GWP Ref	(557)2405
Job Title	Healey Lane, Batley
Client	MTSPV / Connect Homes

Block F Architectural Drawings	
Name	2405-GWP-00-00-D-A-(00)-0020
Scale	1:100@A1
Revision	C05
Drawn/Checked	MK / DT
First Issue	27.06.25
Drawing Status	Technical Design - A04

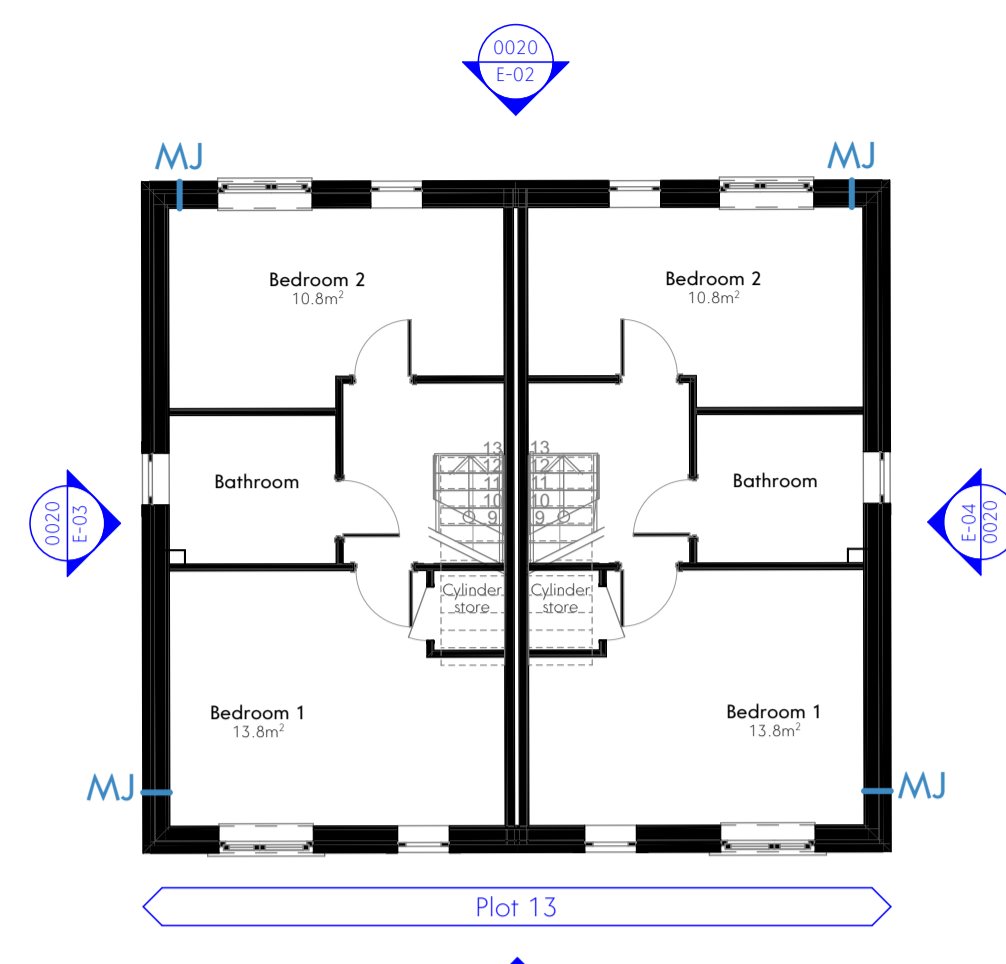
- Notes:**
- Internal road layout revised to suite highway sectional approval (visibility splays to central junction adjusted).
  - Plot A moved by circa 400mm towards N-E and circa 100mm towards S-W to suite retaining wall engineering.
  - Site levels and FFL have been adjusted to reduce landfill/cut, and to suit the as designed adopted highways and site drainage.
  - Changes to boundary treatments to following the revised levels
  - Windows adjusted following building regulations Part O (overheating) assessment. First floor bedroom windows now with double opening sashes (for purge ventilation).
